**\*A. Preliminary/Final Water Quality Plan No. 2013025: New Clarksburg-Damascus Middle School No. 2**

This memorandum covers Staff review and recommendations on the SPA preliminary/final water quality plan.

Re: **Final Water Quality Plan for**  
**Clarksburg/Damascus Middle School**  
**SM File #: 249531**  
**Tract Size/Zone: 22.37 acres/PD-4**  
**Watershed: Little Seneca Creek**

PLAN OF COMPLIANCE  
CLARKSBURG/DAMASCUS SCHOOL  
LITTLE SENECA PARKWAY, CLARKSBURG MD

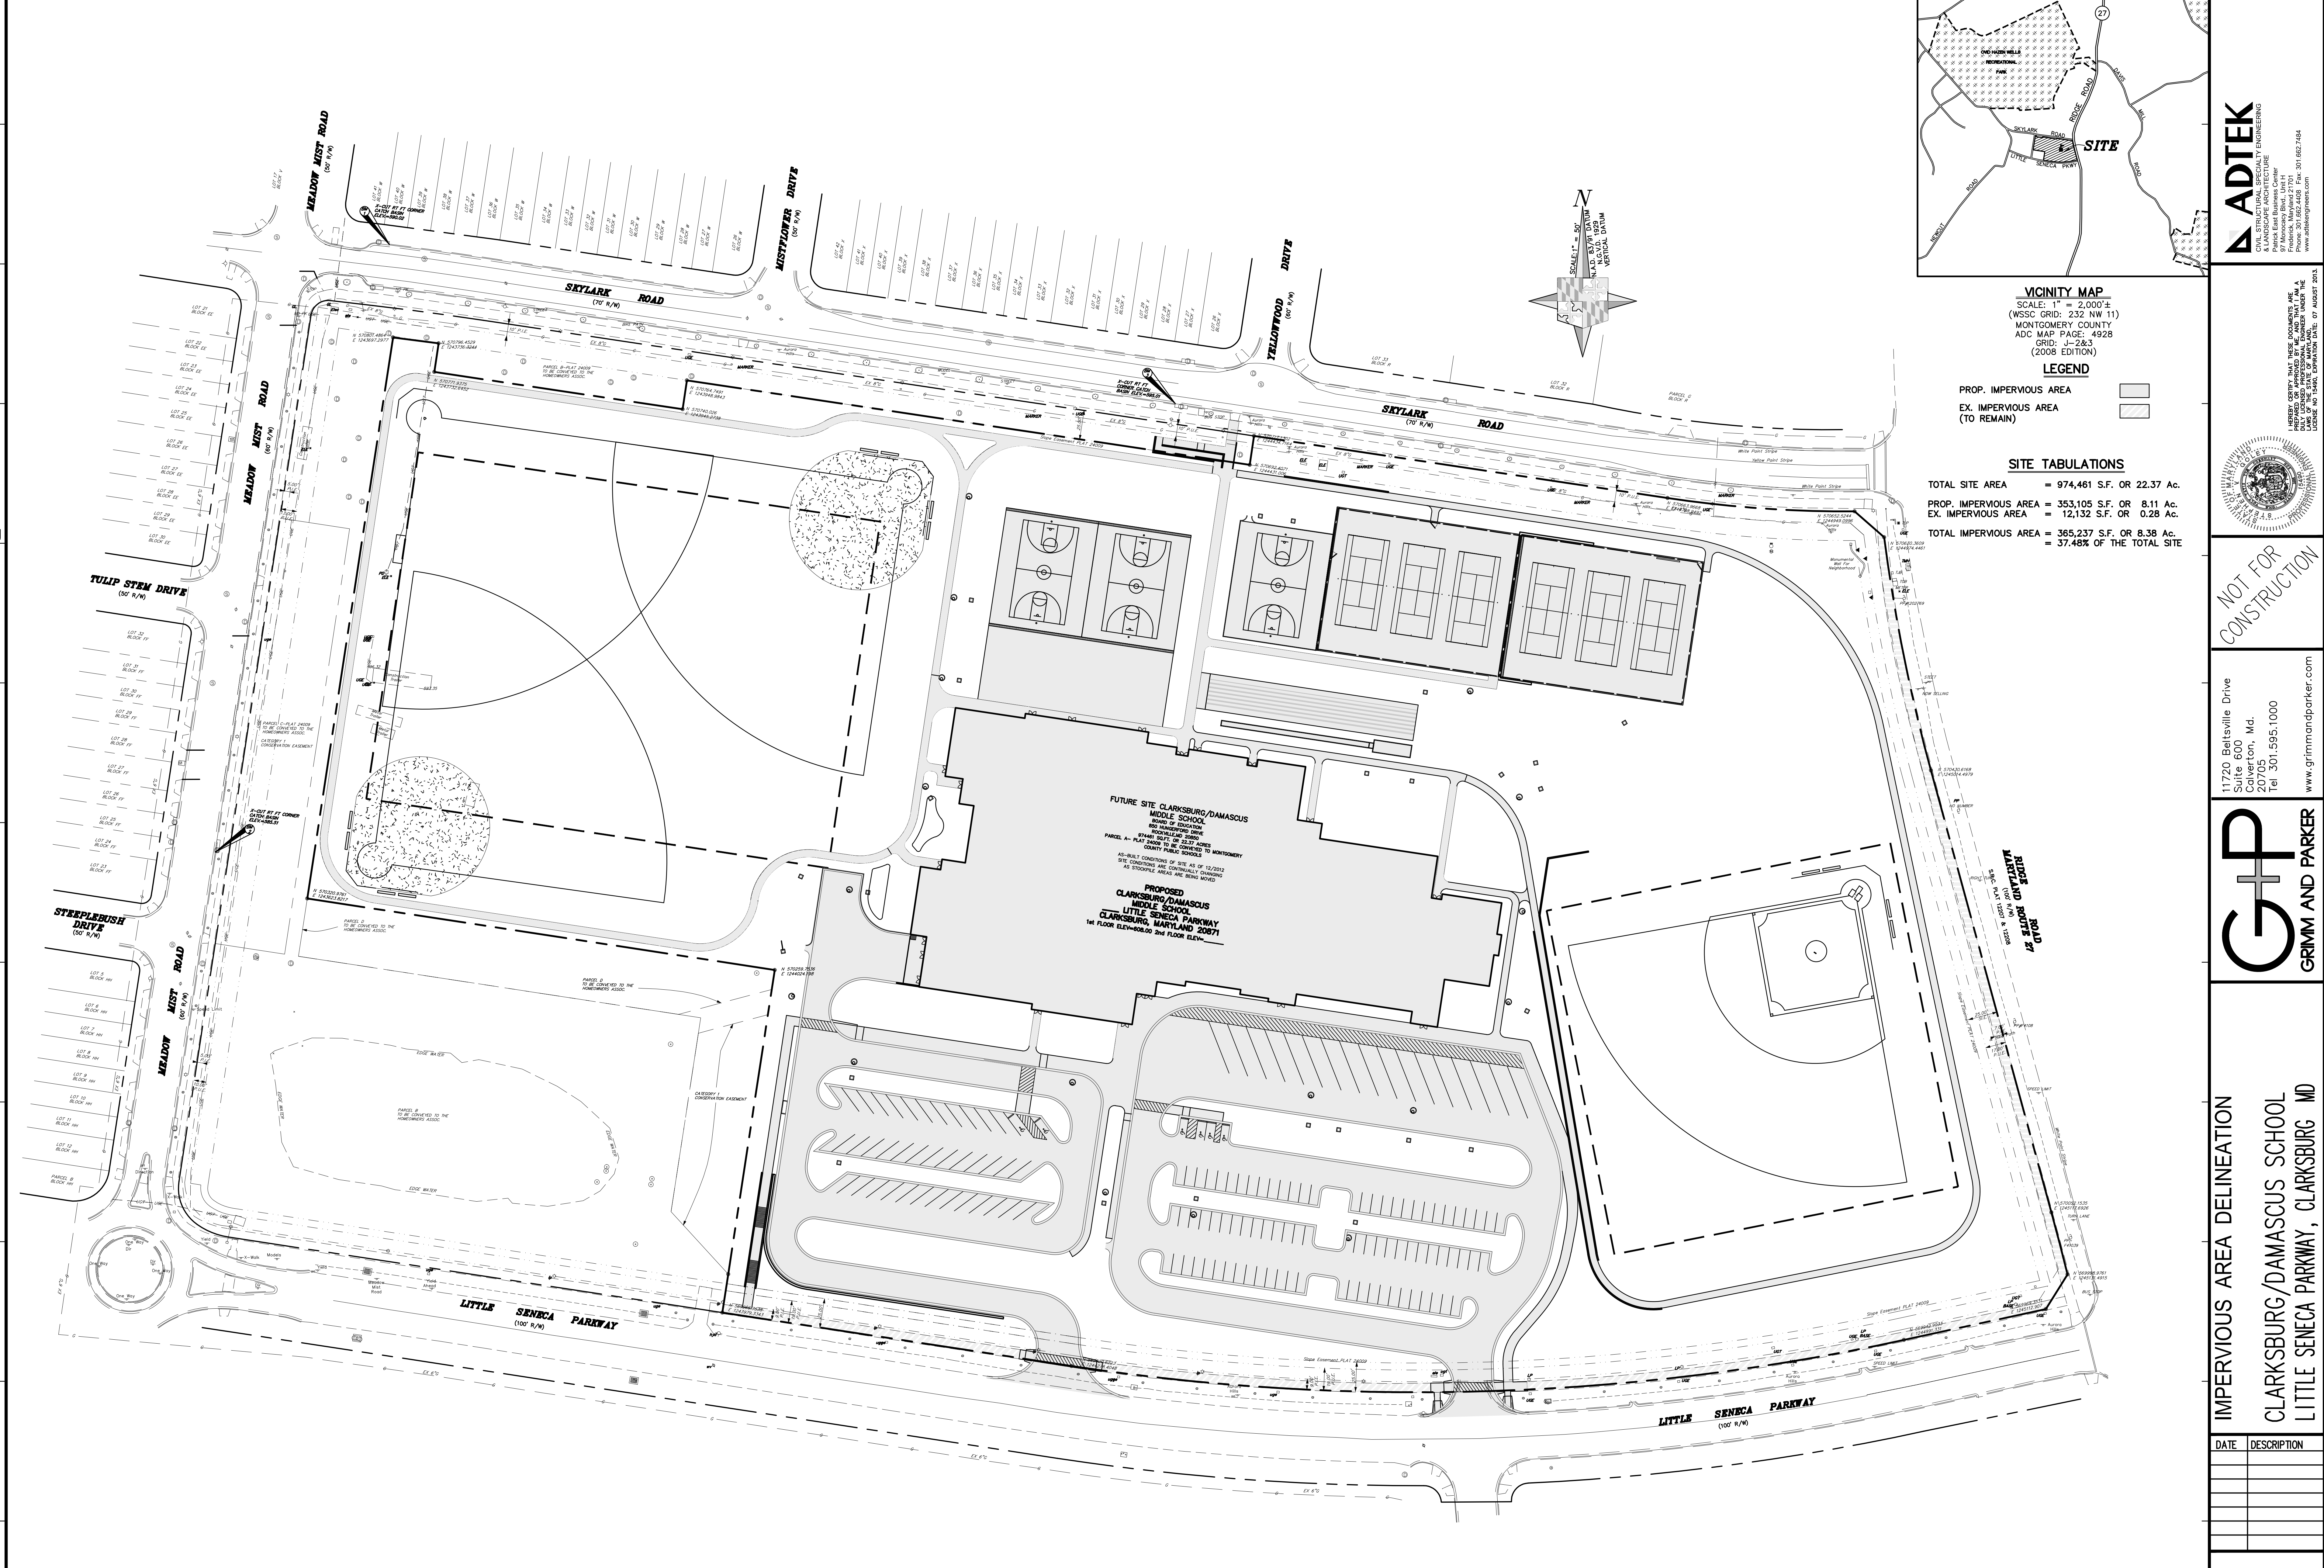
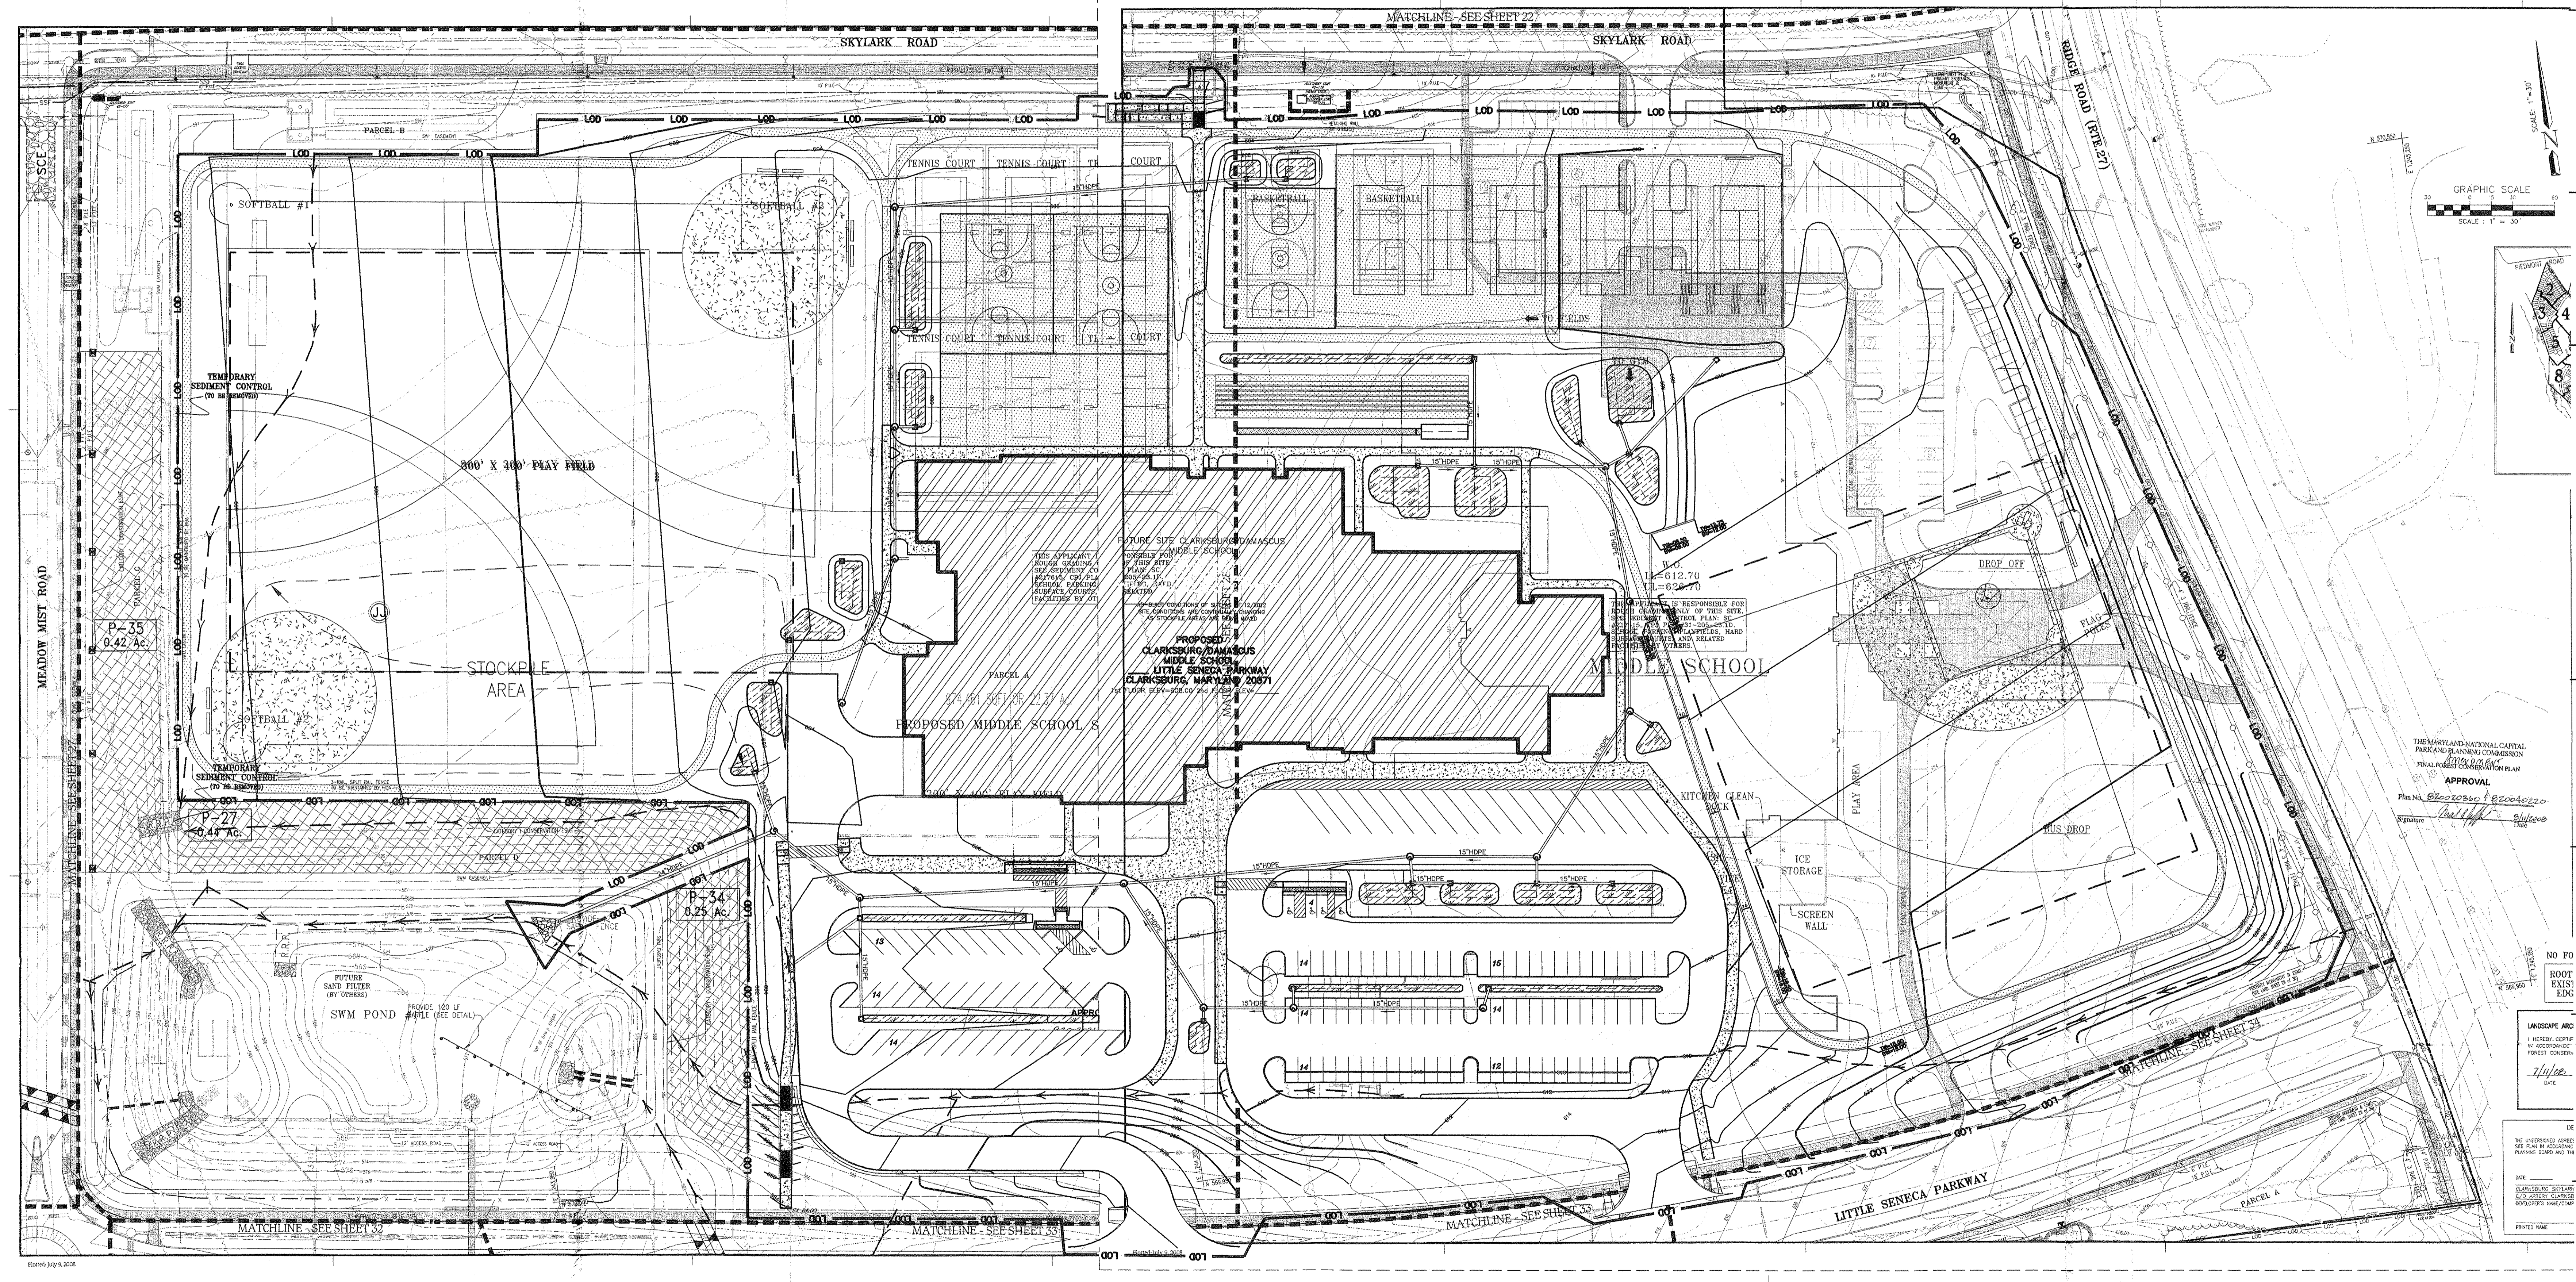
The final forest conservation plan (FCP) for the Site was previously approved as a part of the overall Development (Greenway Village Preliminary Plan #120020330 and Site Plan #820040220). The proposed plans for the school are in full compliance with the previously approved FCP.
